Ref: 542 West Fremont Ave. (APN:323:10:025,026)

Applicant/Owner: Omid Shakeri/Carillo William M Trustee

With reference to the above housing project the following are my concerns. I am also enclosing copies of the layout describing where my concerns are. I have also included photos. However, I am briefly mentioning them below:

PROJECT NAME
**THREE NEW
RESIDENCES**

1 SIDE ELEVATION (SOUTH)
SCALE: 1/4" = 1'-0"

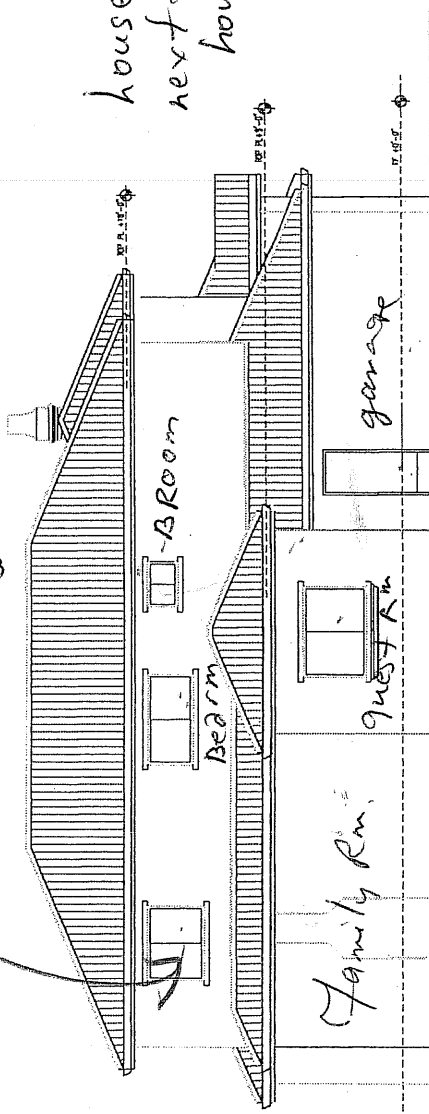
6. Are there two fire places? One layout shows two fire places another layout does not show two fire places how come?
7. I have seen the list of trees mentioned and its conditions. What is going to be the status on the trees from the beginning through the end of my fence? No mentioned is made on this. I would like to see all trees by the fence pulled down.

There are two fireplaces in this house. Not shown how come?

1 SIDE ELEVATION (WEST)
SCALE: 1/4" = 1'-0"

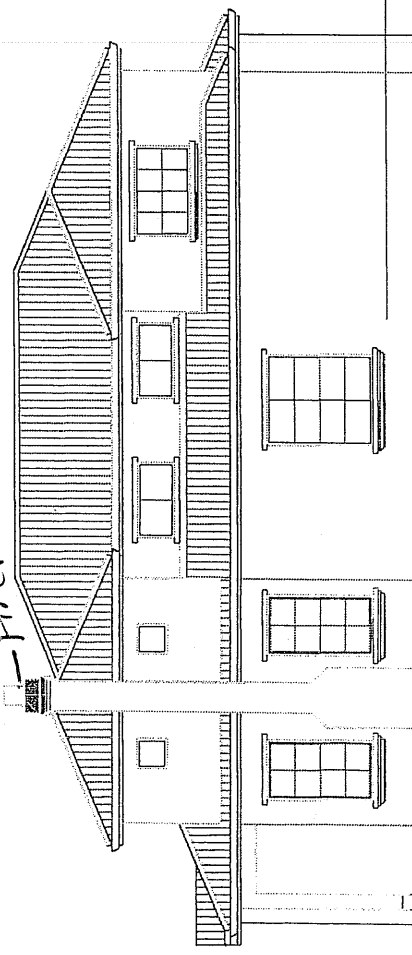
Handwritten note: **fireplace**

SECOND FLOOR PLAN, LOT 1
SCALE 1/4" = 1'-0"

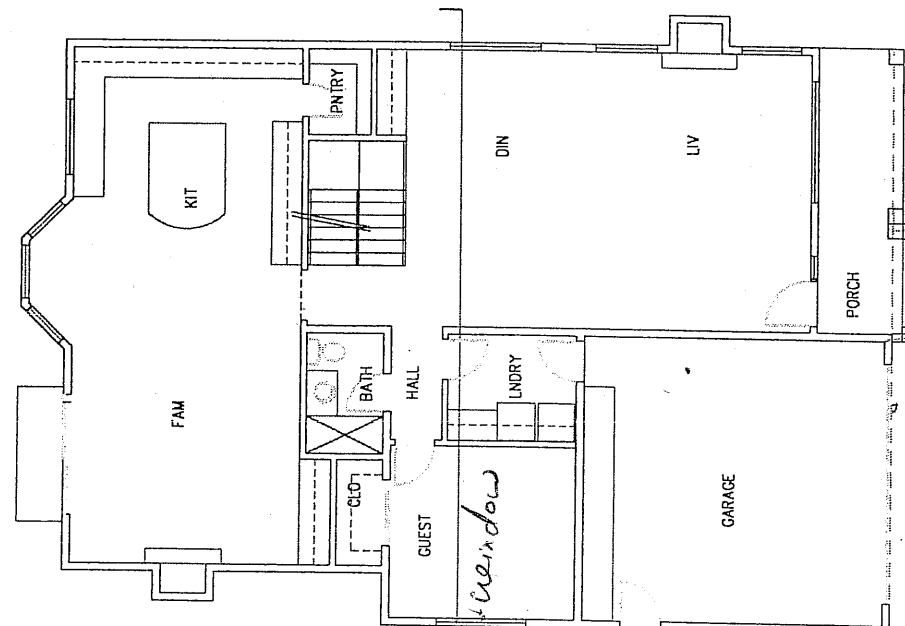
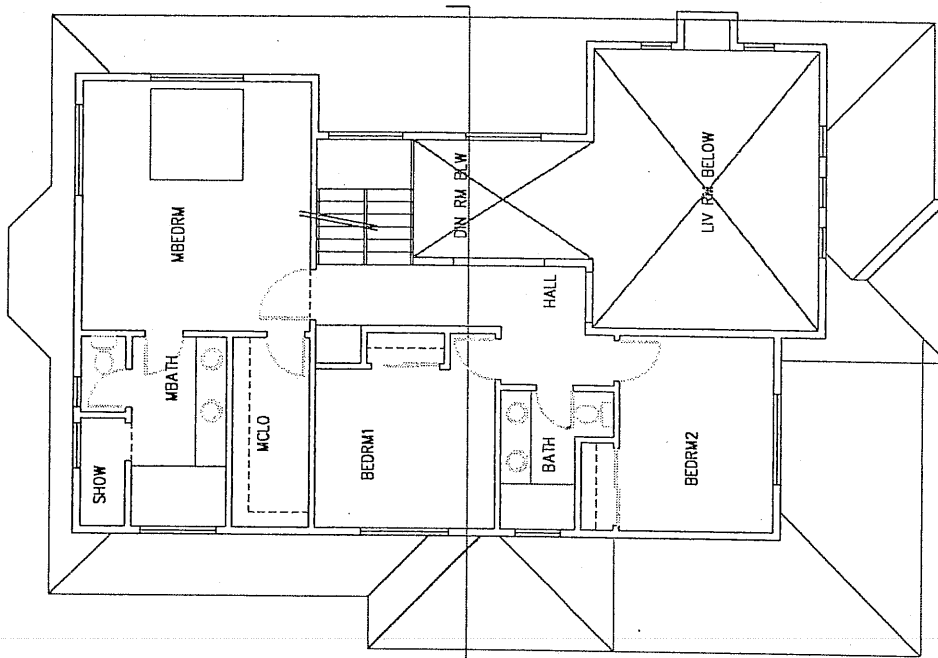
This one shows that there are 2 fire places

Parcel #1

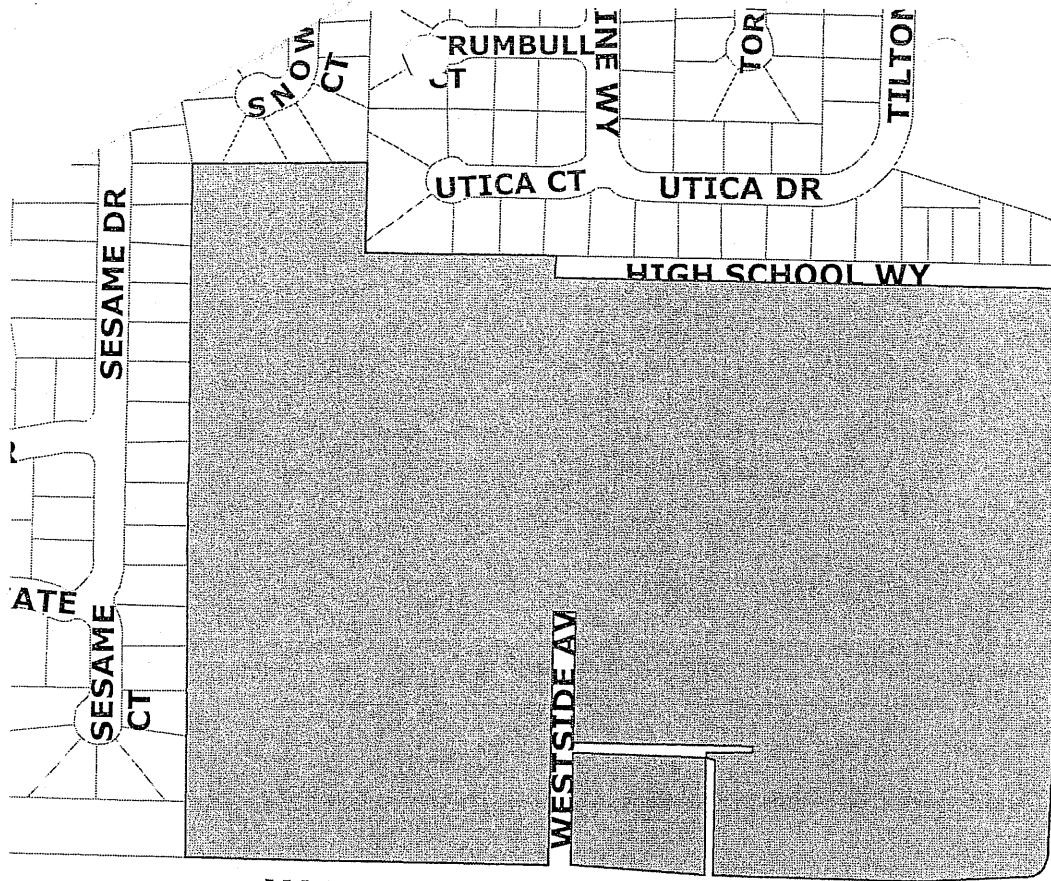
1. Driveway cut seems to encroach on my frontage at the above address; why not do a 90 degree driveway for the new parcel adjacent to mine?
2. Is there any landscaping on the fence area? Fence to be replaced with what? Redwood Fence Material? Solid fence drainage problem is possible. How high is the fence going to be?
3. If you see the marking that I have done it appears to be too close to the property line.
4. Another concern is the unsafe driveway location for the new parcel at the corner of Fremont & Sydney, why not open at Fremont? Fremont High School is right opposite. Many parents drop the kids right round the corner of Fremont and Sydney Drive, this issue has to be taken in with a lot of consideration on your traffic study and needs to be redesigned.
5. All existing 'No Parking At Any Time Signs' MUST stay.

9. We do not need any windows facing our windows on the first or second floor.
10. The house seems too close to the parcel line. The distance between the houses in Parcel 1,2 and 3 is larger than the distance between our property line and the house in Parcel No.1. We need more distance to avoid overhearing of conversations, laughter etc.

your line
